## **NOTICE OF THE REGULAR MEETING OF THE PLAN COMMISSION**

**AGENDA FOR REGULAR MEETING  
VILLAGE OF TINLEY PARK  
PLAN COMMISSION**

**ITEM #2      WORKSHOP – Fox College Parking Lot/Detention Addition, 18020 Oak Park Ave. & 18017  
Sayre Ave. - Rezoning, Plat, Variations & Site Plan Approval**

# PLAN COMMISSION STAFF REPORT

Above: Parking lot expansion site plan.

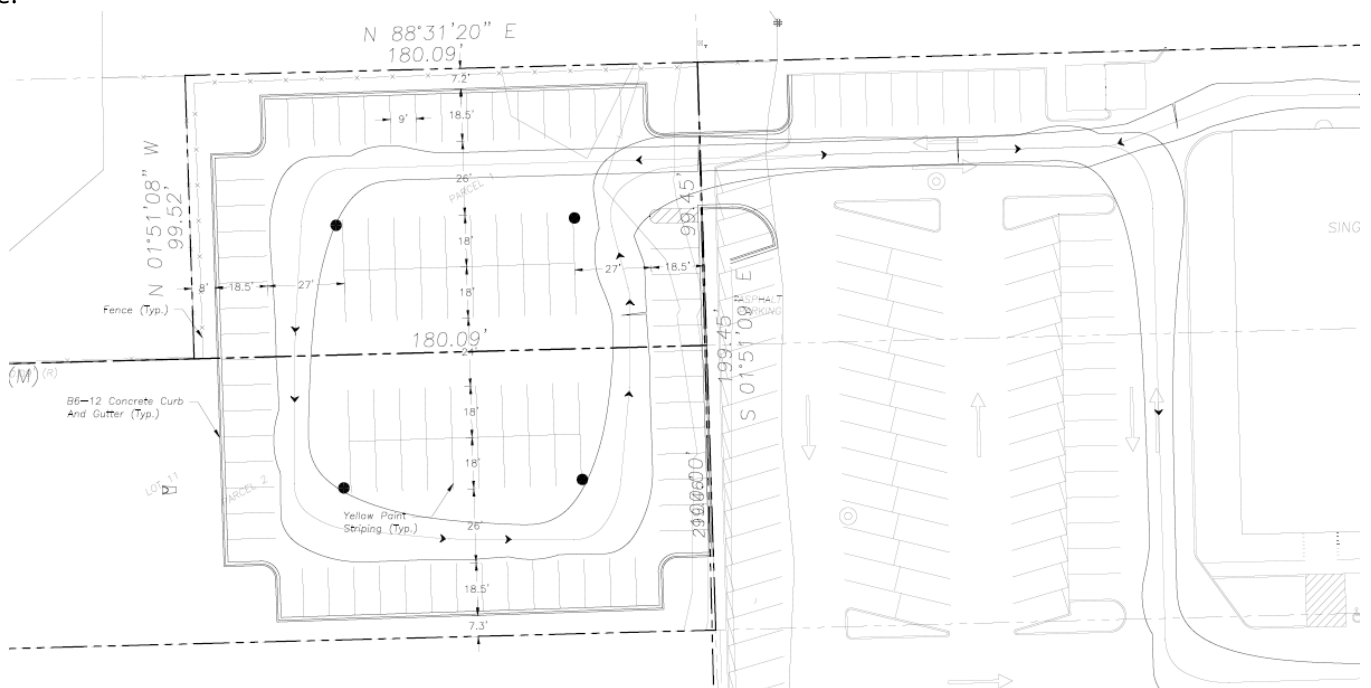
The Site Plan Approval includes the new parking lot, new detention area, and minor changes to the existing site layout. The parking lot has been laid out to maximize the space utilized by parking, while maintaining a reasonable landscape bufferyard.

The new parking lot includes 95 parking stalls and has a mix of 26-foot and 24-foot-wide drive aisles. The Legacy Code only requires 24-foot-wide aisles (whereas the rest of the Village requires 26-foot-wide aisles). However, to accommodate comfortable truck and vehicle circulation through the parking lot addition, the main aisles were maintained at 26 feet wide around the perimeter of the parking lot. Only the interior parking aisle was reduced to 24 feet. The reduction allowed for additional bufferyard width to be added on the north and south sides of the site. The parking lot addition was designed to allow a large fire truck to safely circulate through the site.

### Current Site Changes

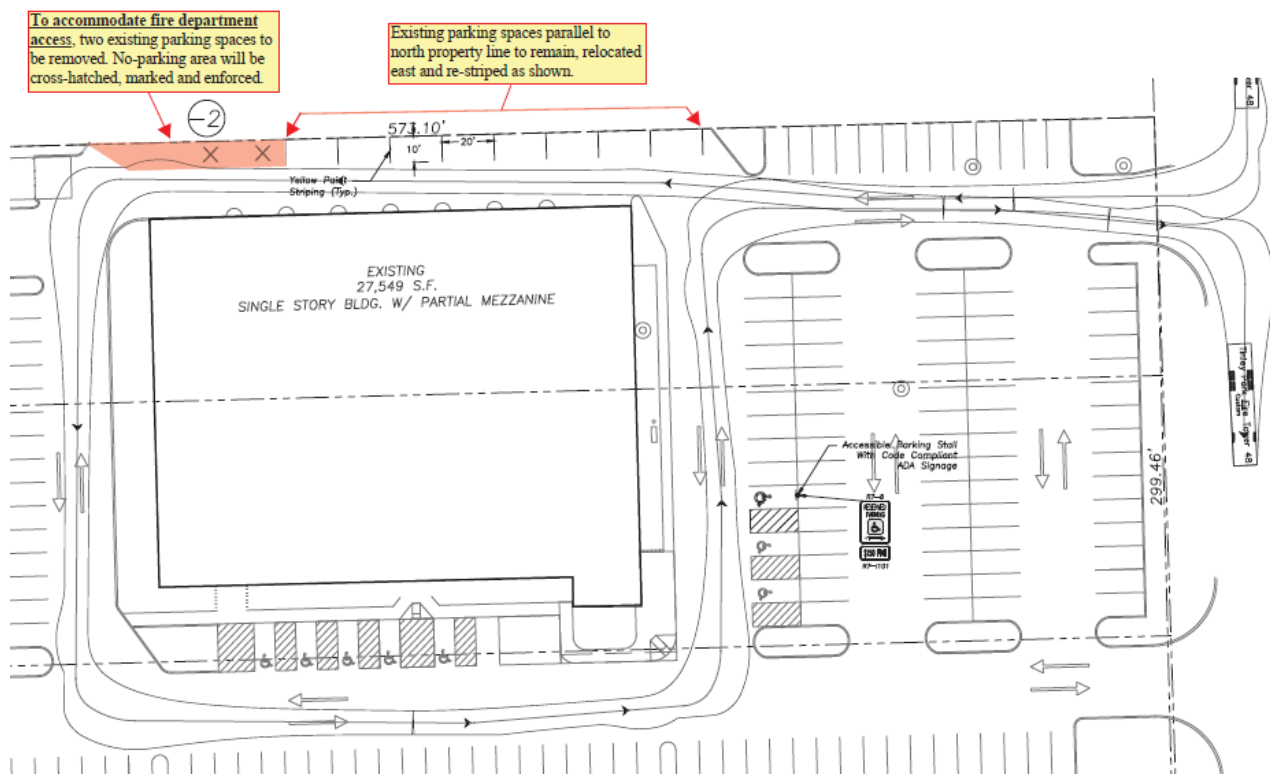
There are parallel parking stalls located on the north side of the property. These stalls were illegally striped without approval and have reduced the aisle width to around 17-18 feet and make truck circulation around the site difficult when vehicles are parked there. To alleviate the truck circulation concern, the petitioner is eliminating two parking stalls nearest to the dumpster to accommodate truck turning. The area will be hashed and marked “No Parking Permitted”. Due to this parking being an immediate issue related to emergency response, the Petitioner has agreed to make these changes this year and is working to get it completed as soon as possible.

The existing aisle width does not meet the aisle width minimum of 24 feet and cannot safely be used as a two-way access. Staff is recommending that this aisle be revised to be a one-way drive aisle with appropriate striping (arrows) and signage (“One-Way →” and “Do Not Enter”). If changes are not made, a Variation would be required.

**Open Item #2: Discuss the overall site plan for the existing site and proposed parking expansion.**

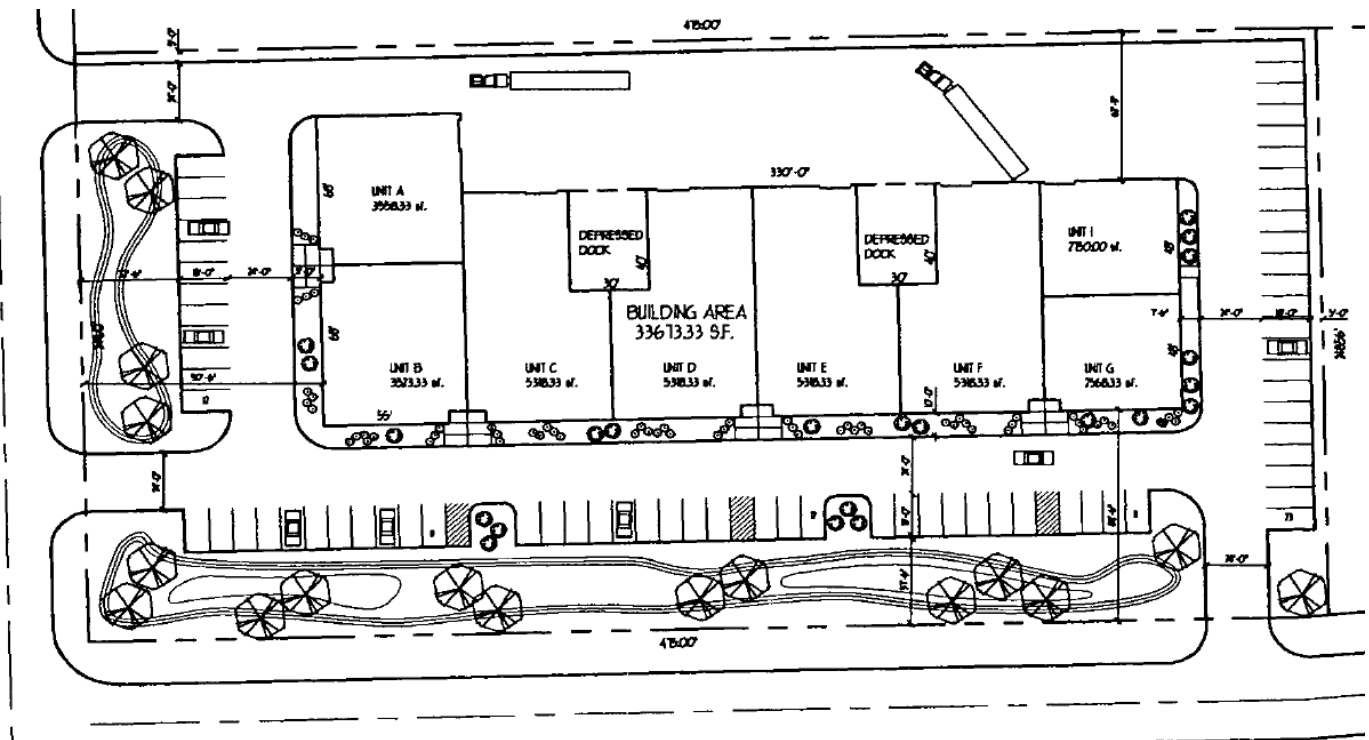
Outdoor patio areas require Site Plan Approval when added to existing spaces to ensure they are well designed, safely located, and do not cause any unintended issues on the site or to surrounding properties. Based on the proposal, the Petitioner requires an exception to the fence requirements due to the patio's location in the front yard of the property and need to enclose the area for a liquor license. Additionally, an exception to the parking minimum is required due to the reduction of parking and increase in seating capacity. The site was originally designed for industrial and office parking demands, which are typically lower than that of commercial properties that the public visits. The Petitioner owns the building and business and has other industrial tenants in the building. However, most are only open and operating during the day and have little activity during weekends and nights when Hailstorm is busiest.

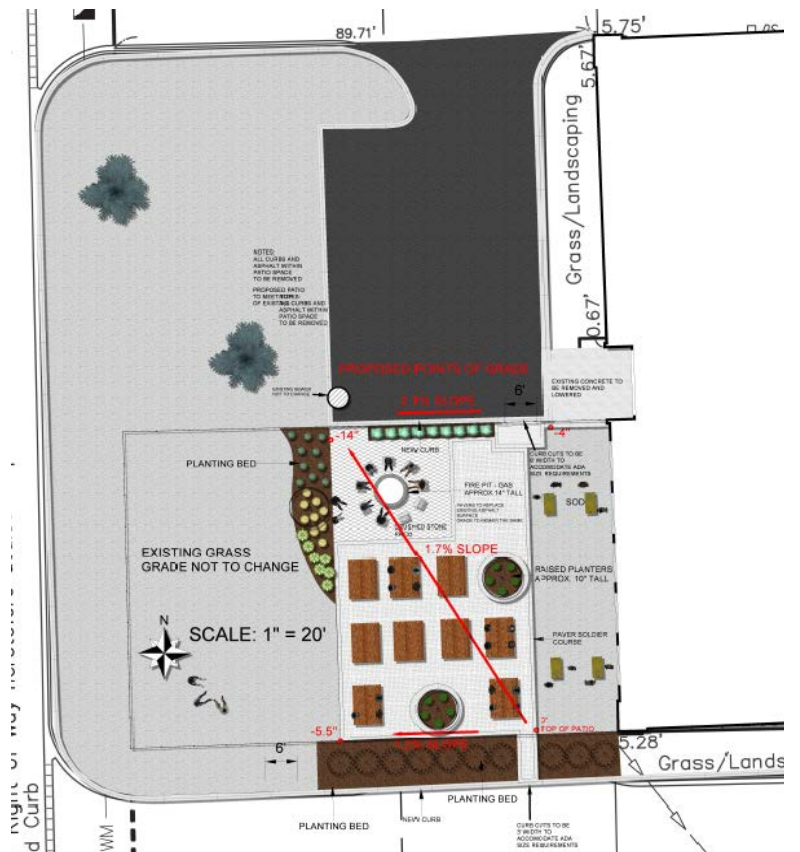
The patio is expected to have a four or five-foot-high fence installed around the perimeter and would only be entered by entering the building. The fence would be a black aluminum fence in the wrought iron style. Fencing is not allowed in a primary front yard on any lot, with the exception of an allowance for patios in the Legacy District. While patios are not typical in industrial areas, it will add an attractive and activated entrance to the business. The fence has a goal of delineating the space where alcohol can be consumed on-premise and helps to protect customers. The proposed fencing will be a 75% open design fence that does not present any visibility or safety issues from the street or driveways.

**Open Item #1: Discuss the requested Exception to the fence regulations to permit a fence to be located in a primary front yard.**
